EPC STORMWATER REVIEW COMMENTS  
IN ORANGE BOXES WITH BLACK TEXT

# Crawford Apartments

## Tract A, Fountain Valley Ranch Fil. No. 6B

**SITE GRADING AND  
EROSION CONTROL PLAN**

**C1.1**

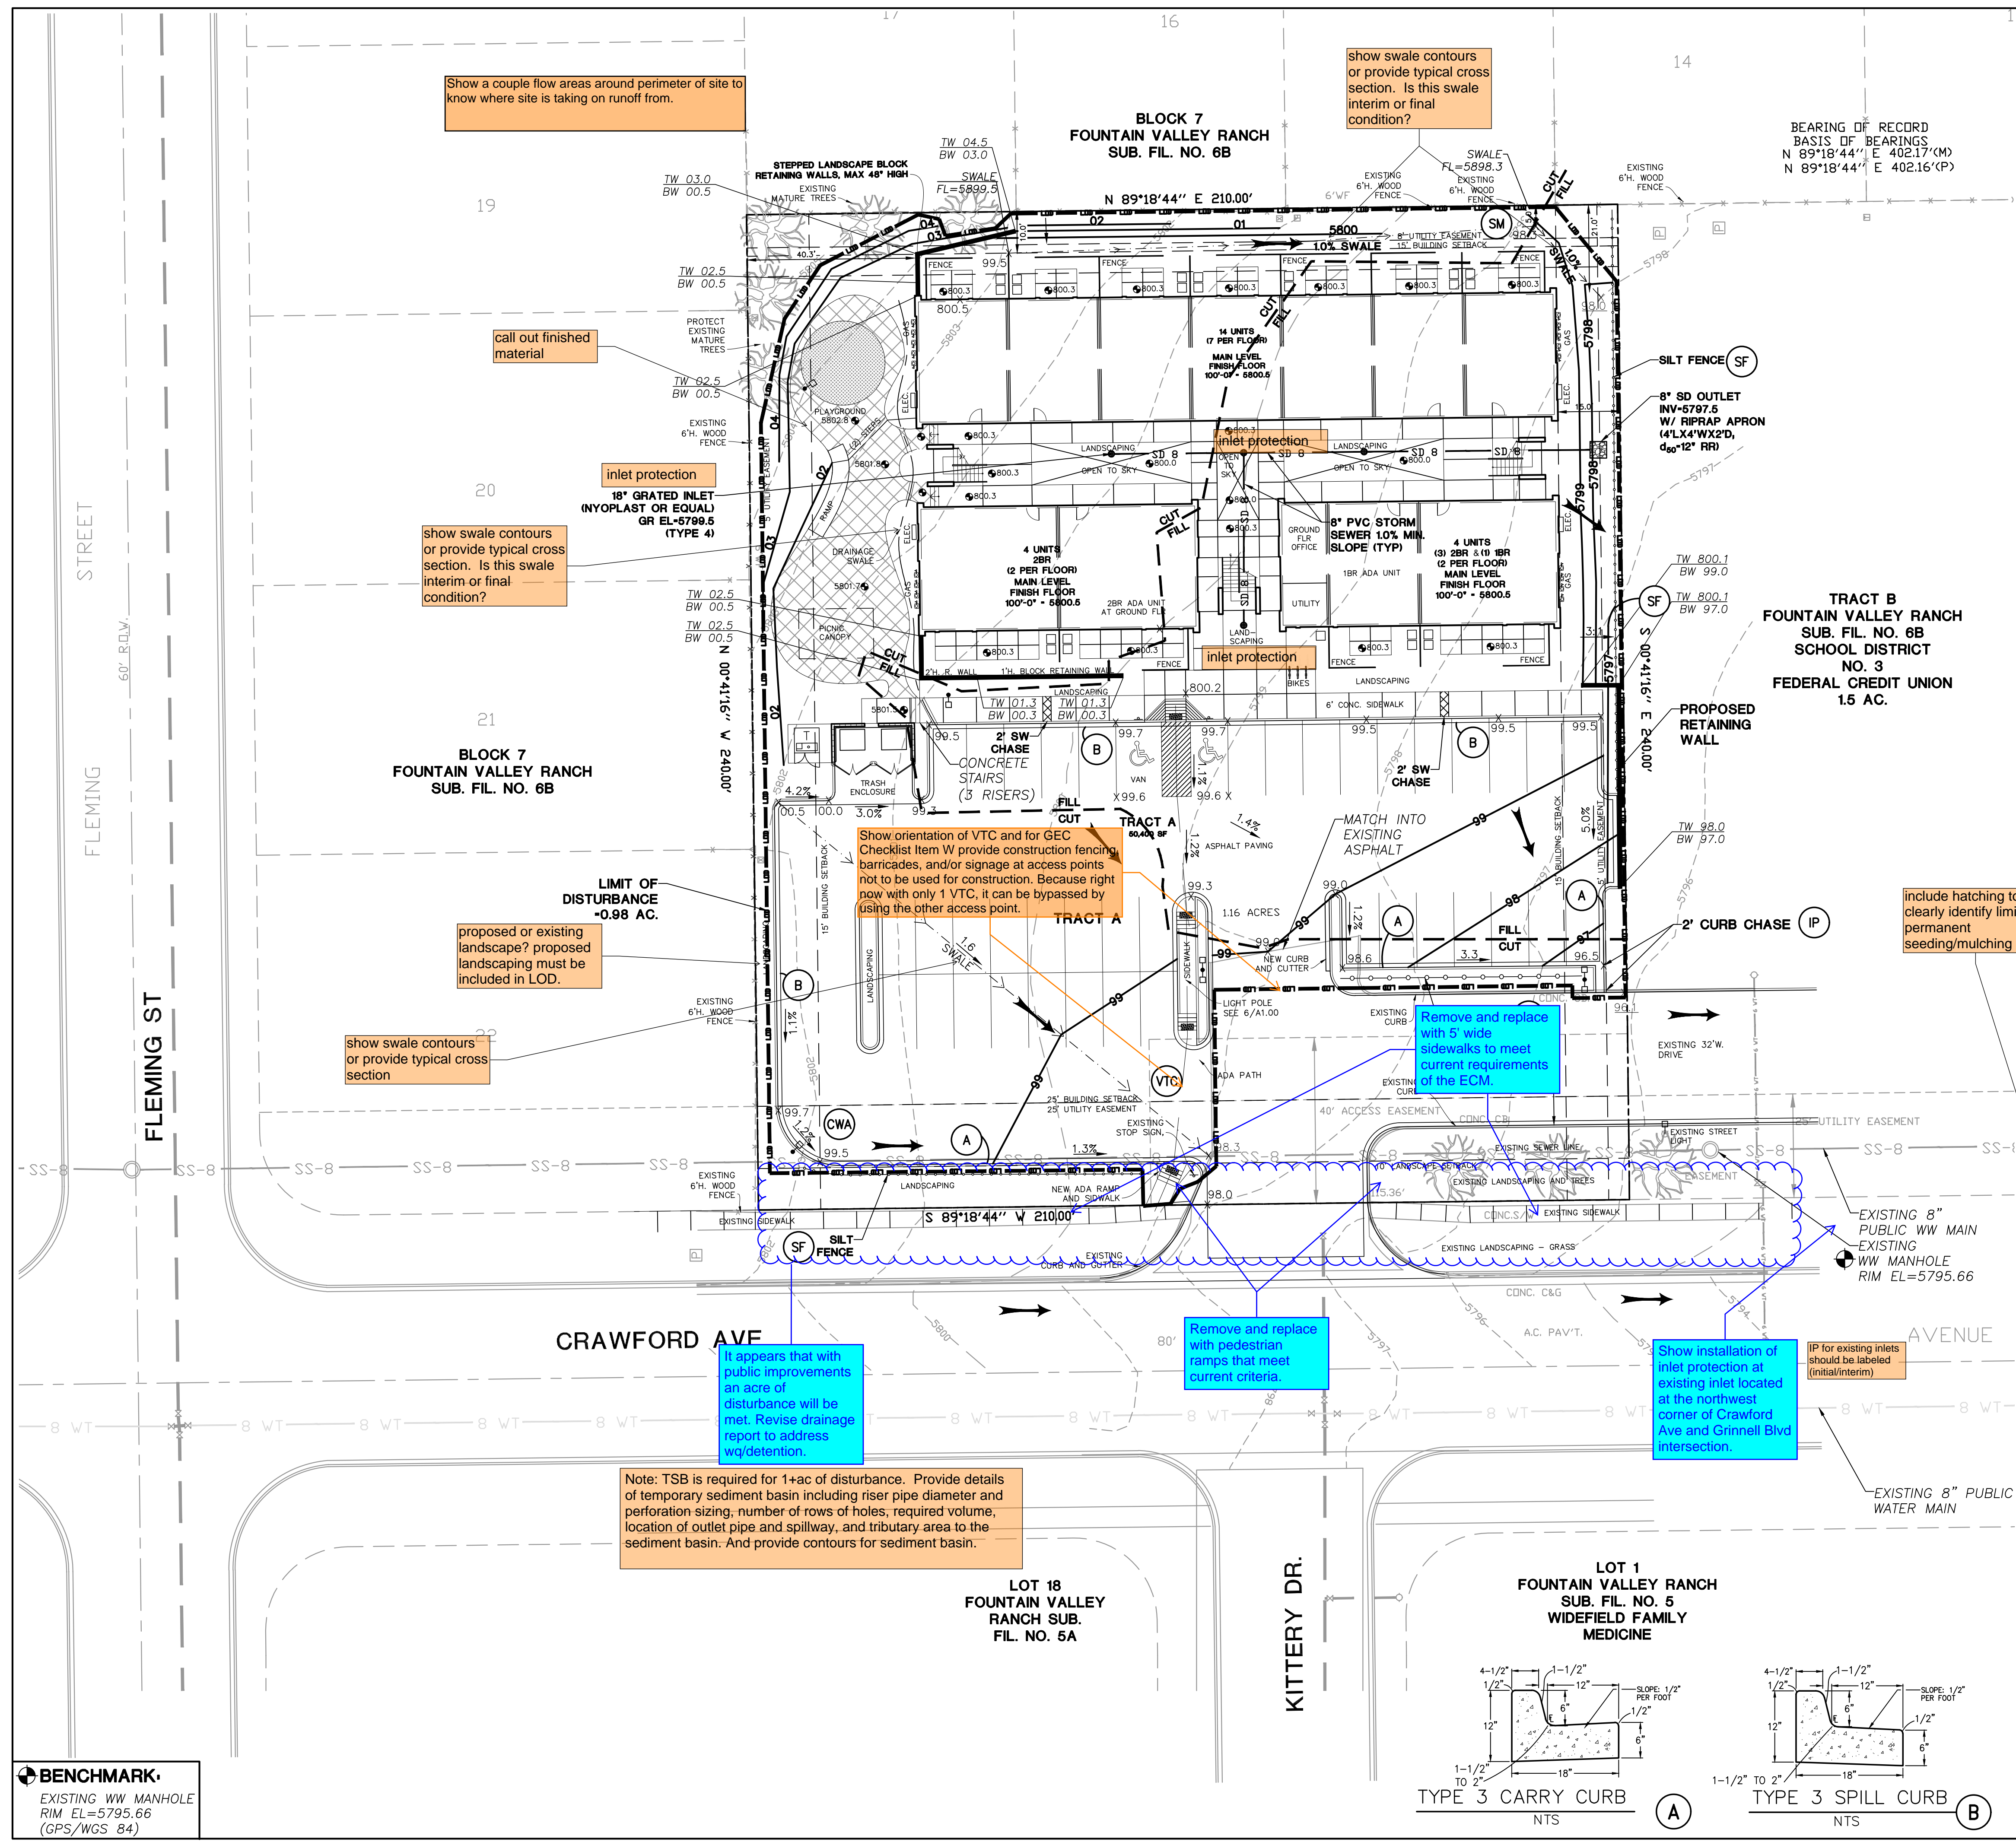
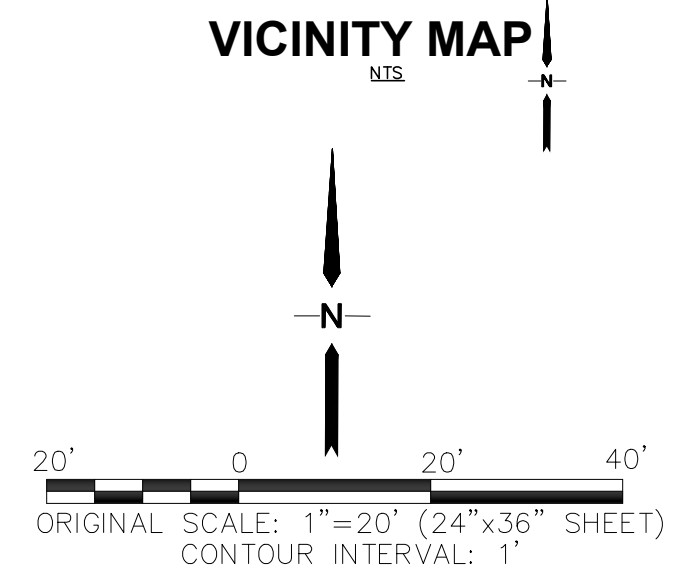
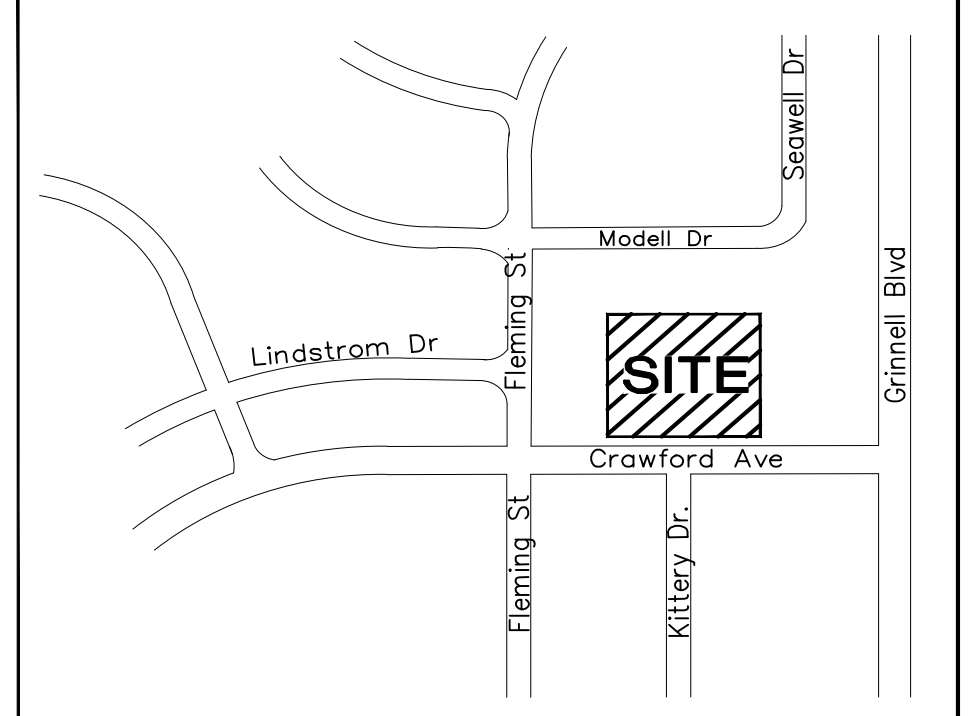
Show a couple flow areas around perimeter of site to know where site is taking on runoff from.

show swale contours or provide typical cross section. Is this swale interim or final condition?

call out finished material

show swale contours or provide typical cross section. Is this swale interim or final condition?

Show orientation of VTC and for GEC Checklist item W provide construction fencing, barricades, and/or signage at access points not to be used for construction. Because right now with only 1 VTC, it can be bypassed by using the other access point.

proposed or existing landscape? proposed landscaping must be included in LOD.

show swale contours or provide typical cross section

include hatching to clearly identify limits of permanent seeding/mulching

Remove and replace with 5' wide sidewalks to meet current requirements of the ECM.

It appears that with public improvements an acre of disturbance will be met. Revise drainage report to address wq/detention.

Remove and replace with pedestrian ramps that meet current criteria.

Show installation of inlet protection at inlet located at the northwest corner of Crawford Ave and Grinnell Blvd intersection.

Note: TSB is required for 1+ac of disturbance. Provide details of temporary sediment basin including riser pipe diameter and perforation sizing, number of rows of holes, required volume, location of outlet pipe and spillway, and tributary area to the sediment basin. And provide contours for sediment basin.
